CITY OF ALBUQUERQUE

Re: Animal Humane Park Phase 1
615 Wyoming Blvd SE
Traffic Circulation Layout
Architect's Stamp 11-15-16 (L19D058)

Based upon the information provided in your submittal received 11-15-16, the above referenced plan cannot be approved for Building Permit until the following comments are addressed:

SHEET NO:
A1.3

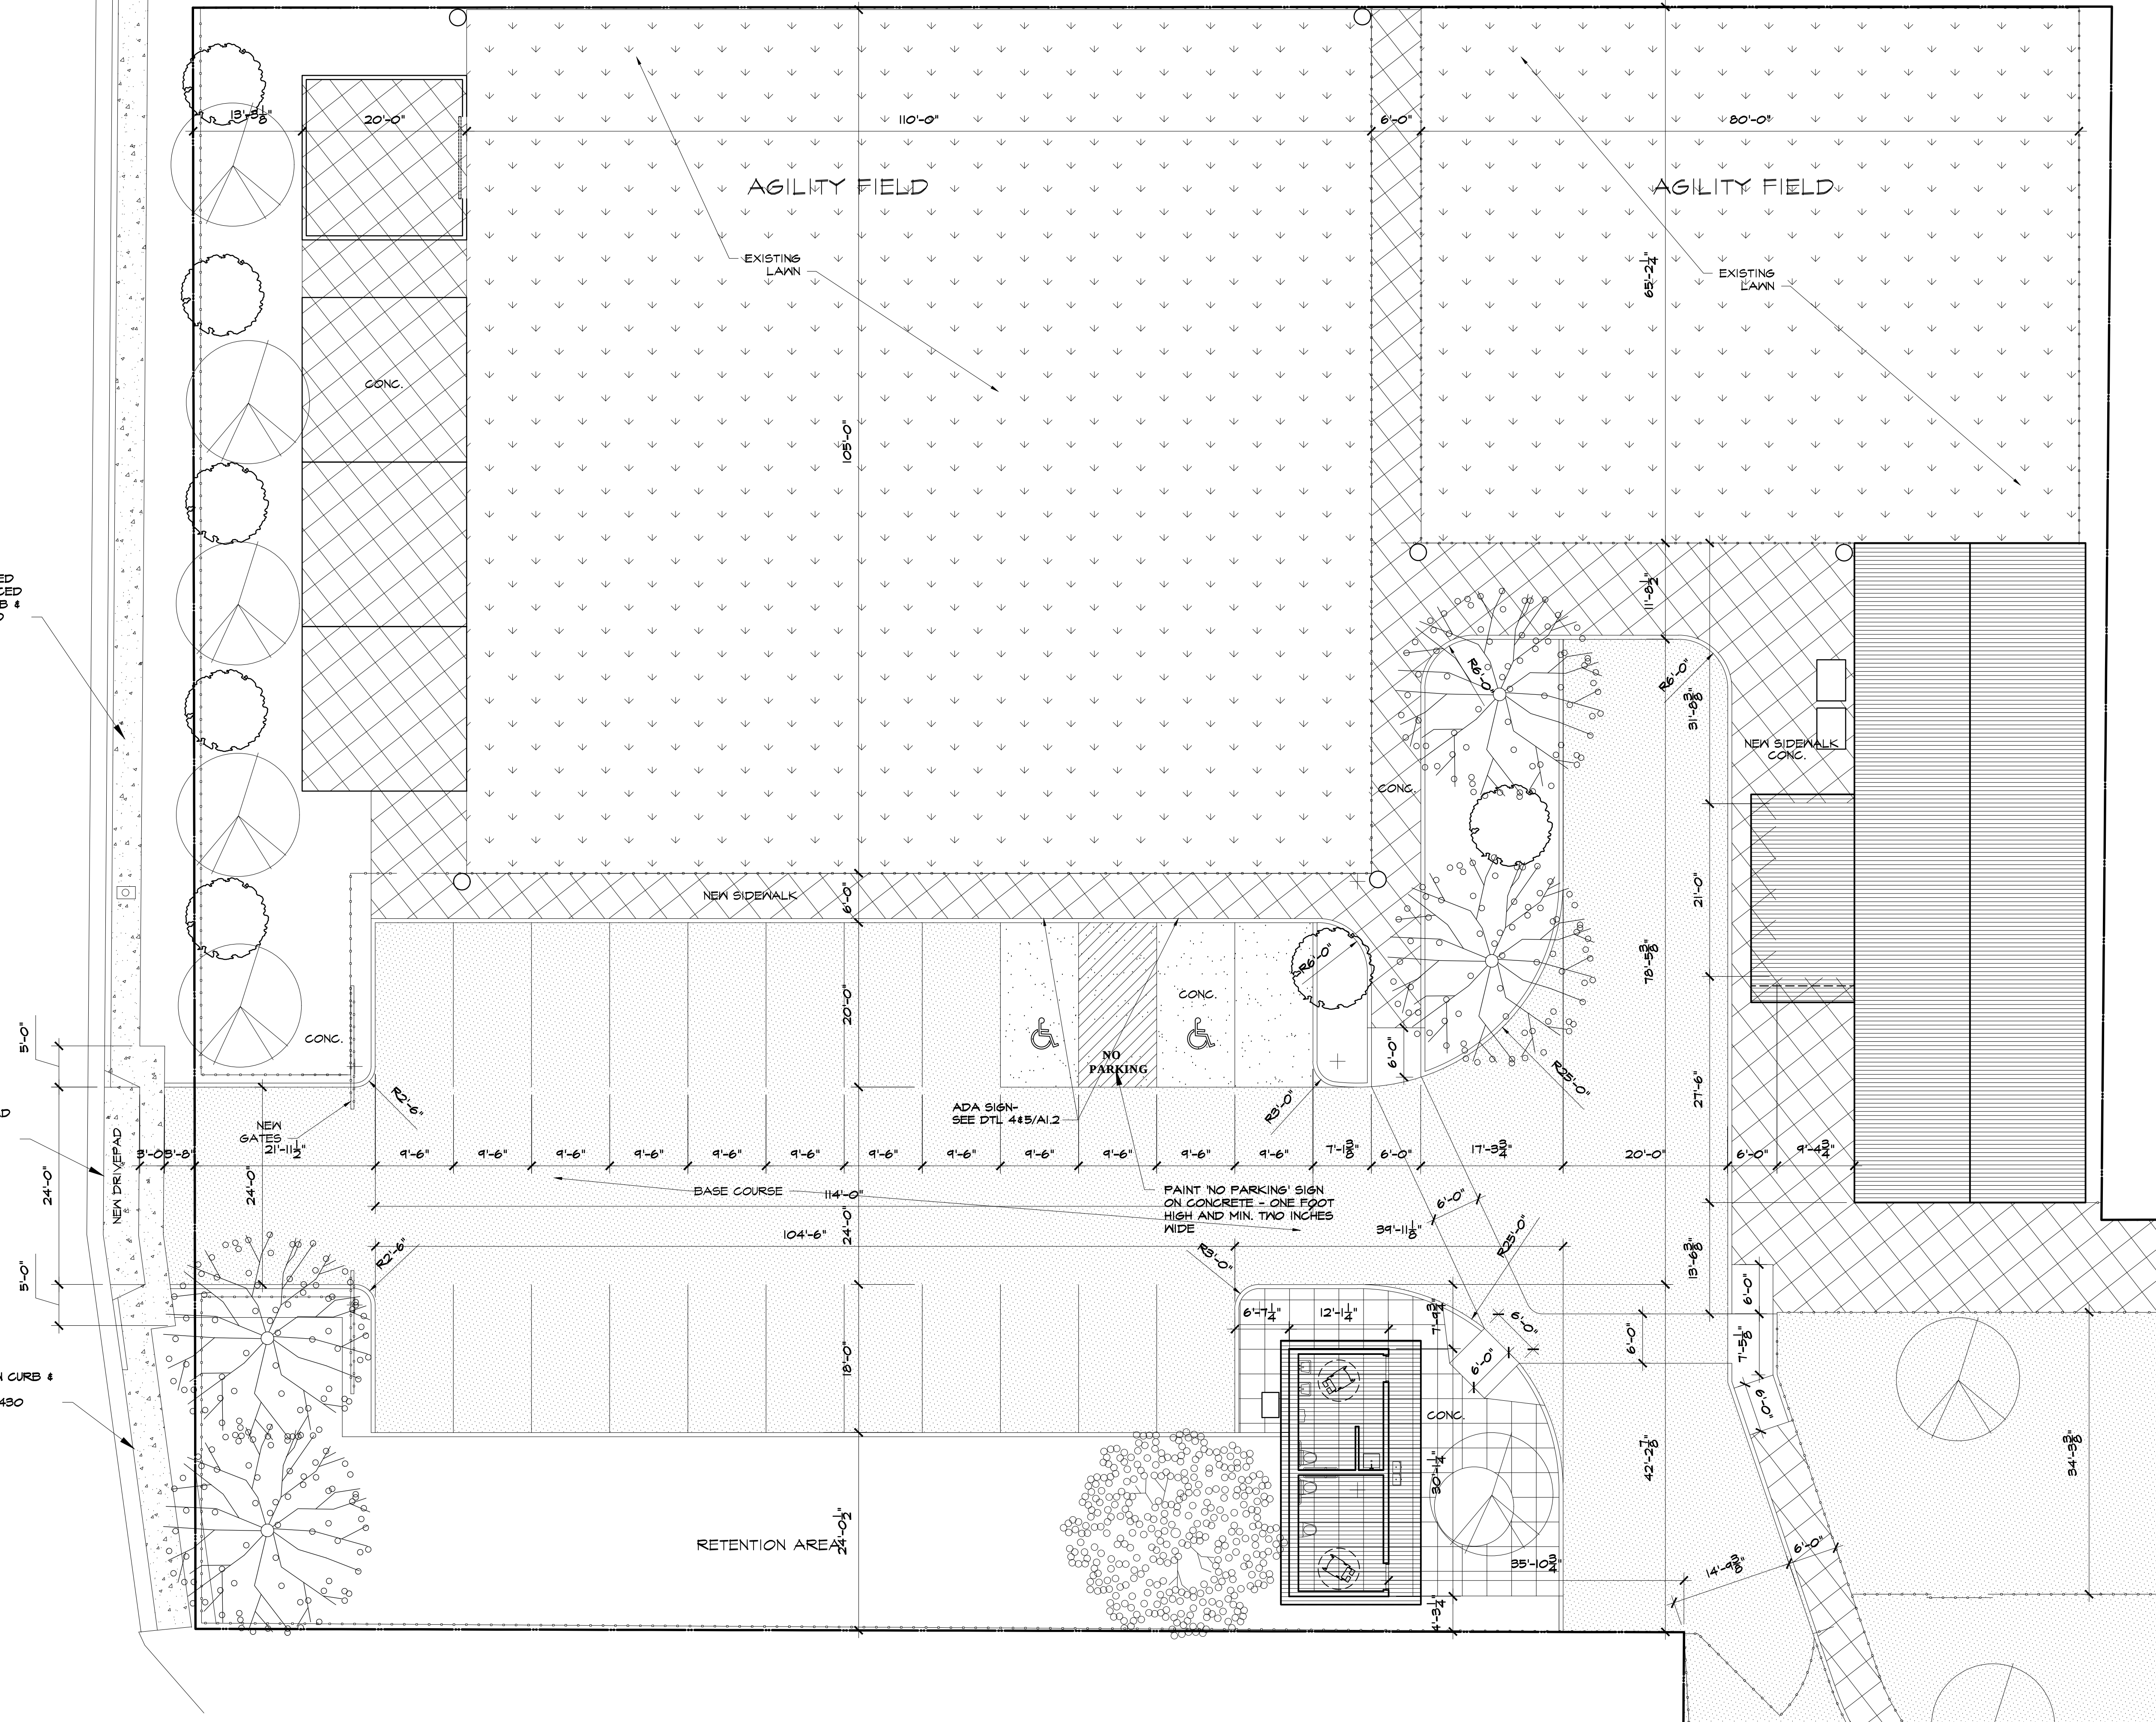
1. List the number of parking spaces required by the zoning code for each phase as well as the proposed number of parking spaces including bicycle and motorcycle parking.
2. Identify the right of way width, medians, curb cuts, and street widths on Virginia St SE.
3. Show the clear sight triangle and add the following note to the plan:
"Landscaping and signage will not interfere with clear sight requirements. Therefore, signs, walls, trees, and shrubbery between 3 and 8 feet tall (as measured from the gutter pan) will not be acceptable in the clear sight triangle.
4. Please specify the City Standard Drawing Number when applicable.
5. Please include two copies of the traffic circulation layout at the next submittal.
